Light Water Reactor Sustainability Program

Preliminary Human-System Evaluation of Thermal Power Dispatch Concept of Operations

September 2020

Figure 20. Prototype HSI depicting the non-functional alarms and the mode indicators, which were confused by the operators.

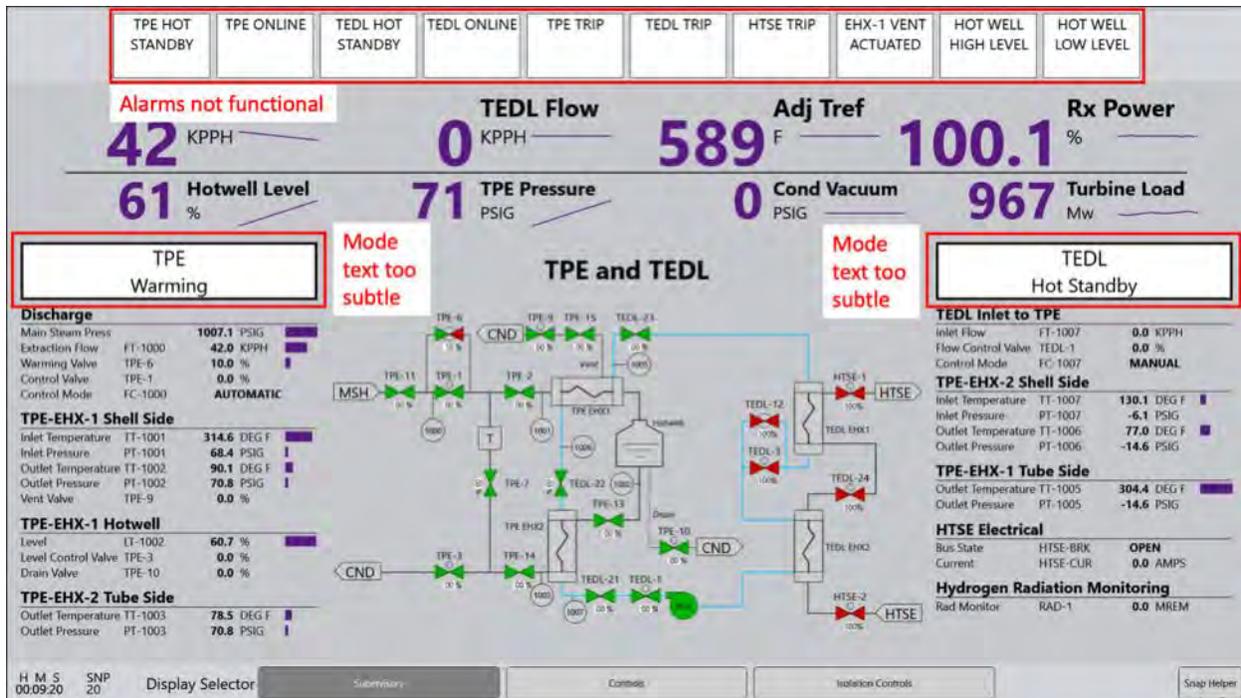
The alarms along the top of the display were included as placeholders for future testing for abnormal and emergency scenarios (see Figure 20). As a result, they were not the focus of this study, and the simulation data did not have corresponding points for those alarms, which rendered them nonfunctional within the prototype. This in itself is not an issue as it was known to the research team. It did factor into the evaluation because several operators confused the alarms for the mode indicators referenced in the procedure instructions to check the state of TPE and TEDL. There were several contributing reasons for this confusion. First, the mode indicators are quite similar in appearance to the alarms as they both have near white shading for their backgrounds with black text. Second, the mode indicators used a change in the text underneath the TPE and TEDL labelling to denote the mode as Shutdown, Warming, Hot Standby, and Online. The text change went unnoticed by several operators and, as a result, it was not clear that these were indicators. They were confused for column headers to denote the tables of data below them and were associated with the TPE and TEDL systems respectively.

Figure 21. HSI control display depicting issues associated with the configuration of the controllers themselves that did not align with the interaction expected by the operators to manipulate controller.

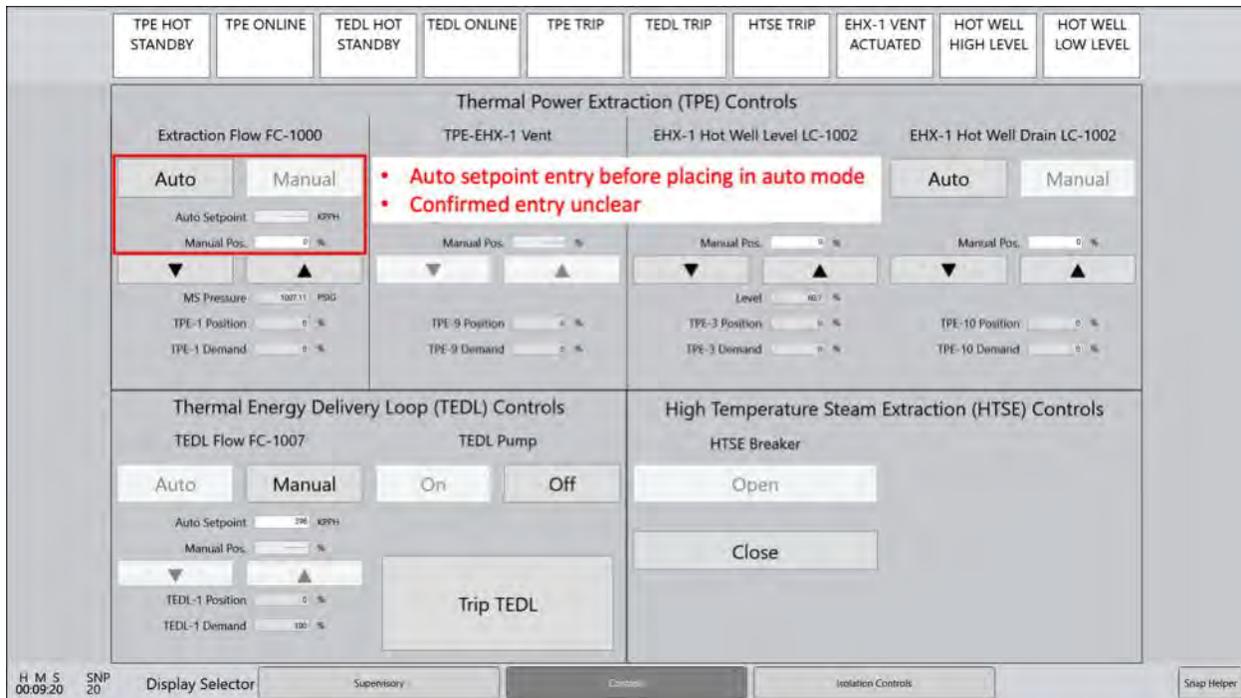
The controls display contains flow and level controllers for the control valves used to manipulate flow in the TPE and TEDL systems. The operators reported that the layout of the control grouping was logical and organized in a manner they easily understood. However, the operators and observers noted several issues with the controls display. The bulk of the issues pertain to the configuration of the controllers themselves (see Figure 21). Each controller has an automatic and manual mode of operation. In automatic mode, the operator can enter the desired setpoint value and activate the control by pressing the enter key. A confirmation dialog is presented to confirm the desired action and to enter the setpoint into the system. To make the mode of operation more salient, the auto setpoint or manual position for each controller was greyed out when in the manual or auto mode respectively. As a result, the operators were forced to place the controller into auto mode and input the desired setpoint. As reported by all operators, this is the reverse of how the interaction should take place because the last auto setpoint entered will be the value towards which the system begins to move when it is placed in auto. This might not be the value that the operator desires. Therefore, both entry fields for auto setpoint and manual will be able to receive input at any time. The setpoint and manual entry fields were part of another issue. It was difficult for the operators to discern if a value had been registered by the system. One recommendation that was provided and adopted is to color code the numeric entry text so that when a number is typed into the field, it remains red to indicate it has not been accepted into the control logic. After confirming the entry, the text changes to green to denote that the system has accepted the value and is using it to control the process.

Figure 22. HSI control display depicting indication reported as necessary to monitor the feedback of the process being controlled by the controller.

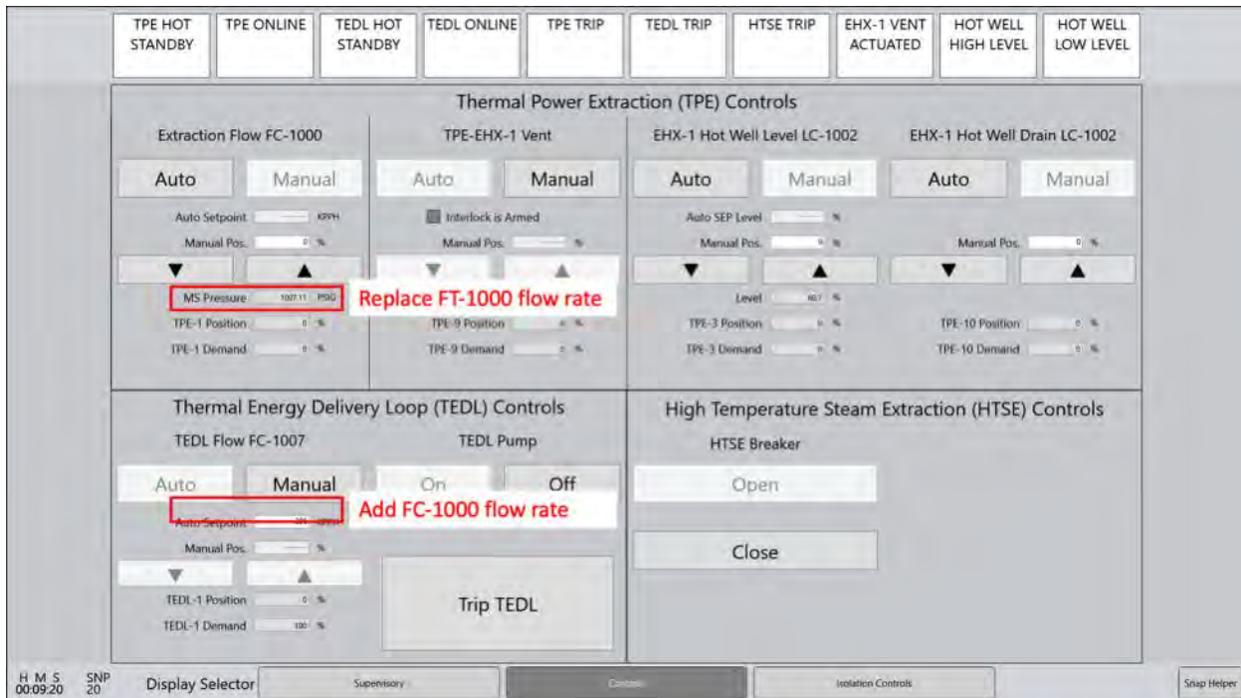
The operators also reported that the MS Pressure indicator parameter in the Extraction Flow FC-1000 controller was the wrong process parameter and should be replaced by the FT-1000 flow rate indicator. Similarly, the operators reported that they would like the process parameter for TEDL Flow FC-1007, which is the FC-1000 flow rate indicator, included in the control so the process could be monitored without having to return to the supervisory display to see the feedback from the controller.

Figure 27. HSI supervisory display with updates made based on the operator study.

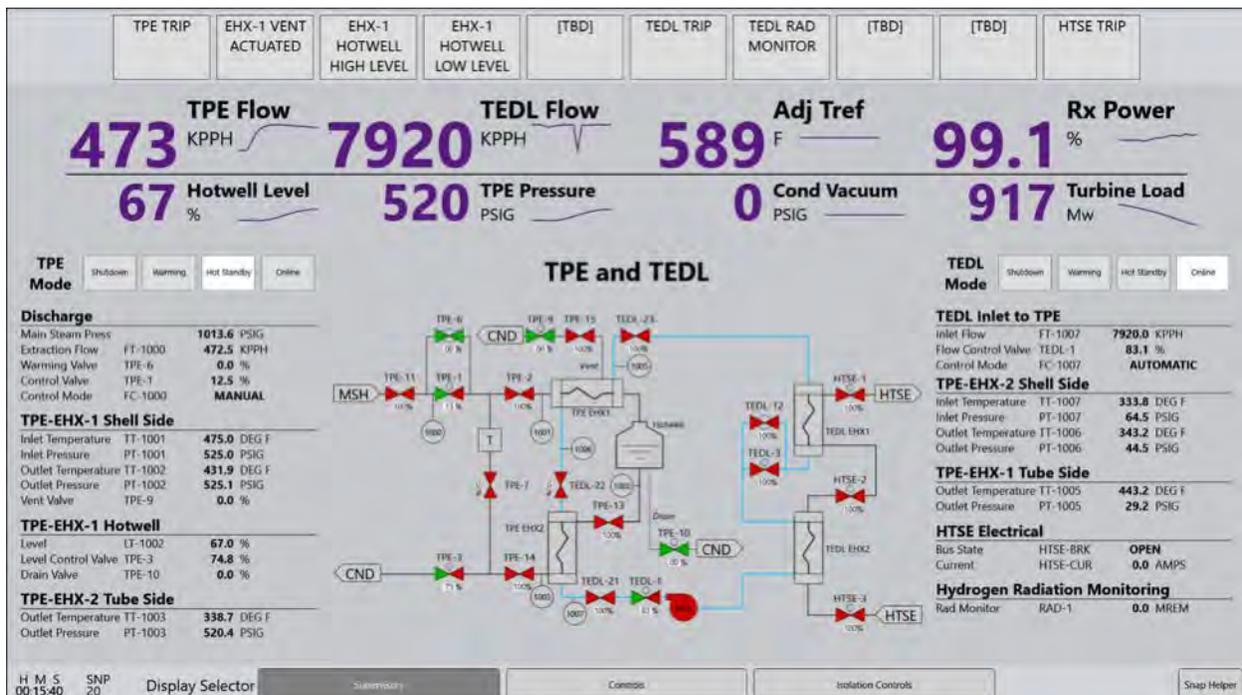
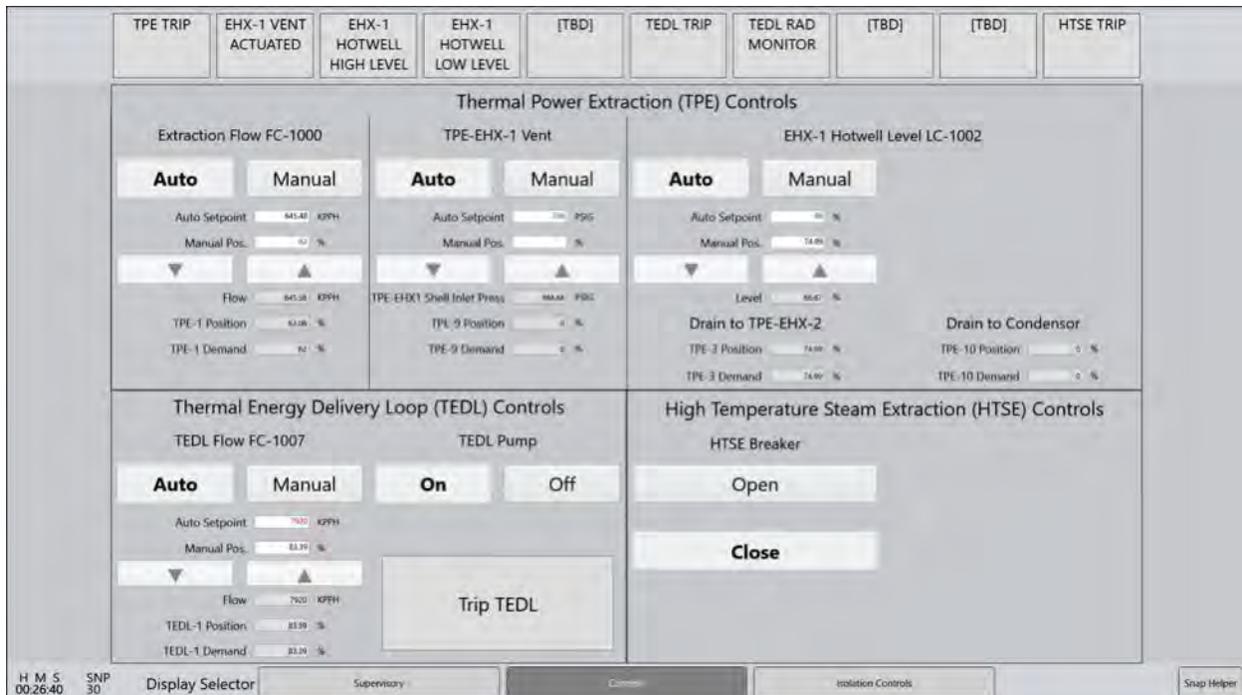
The updates to the interface are many, and details can be found in section 3.6 on the HSI, but a few are worth highlighting here. The TPE and TEDL mode indicators were changed to show four separate indicators for Shutdown, Warming, Hot Standby, and Online. Only one indicator is illuminated to denote the mode. This scheme was much more salient than the text change used in the study (see Figure 27). The bar graphs were removed because they were reported to be unhelpful and to create a less cluttered and cleaner interface and make it easier to extract an individual value from the data tables. The orientation and flow paths for the TPE-EHX-1 and TPE-EHX-2 heat exchangers were corrected. In the control display, controllers were updated to use a red and green color scheme. Values that had been entered, but not yet accepted by the system, are now shown in red. After the system accepts the values, the color of the values changes to green to indicate the system acceptances entered (see Figure 28). Furthermore, the interlock indication was removed in leu of the auto and manual mode indication to remove ambiguity and maintain consistency.

are mentioned here. The thermal power extraction line and thermal power delivery loop mode indicators were changed to show four separate indicators for Shutdown, Warming, Hot Standby, and Online. Only one indicator is illuminated to denote the mode. This scheme was much more salient than the text change used in the study (see Figure 27). Bar graphs indicating key parameters were removed because they were reported to be unhelpful. Removing the bar graphs resulted in a cleaner interface that made it easier to extract individual values from the data tables. The orientation and flow paths for the TPE-EHX-1 and TPE-EHX-2 heat exchangers were corrected. In the control display, controllers were updated to use a red and green color scheme. Values that had been entered, but not yet accepted by the system, are now shown in red. After the system accepts the values, the color of the values changes to green (see Figure 28).
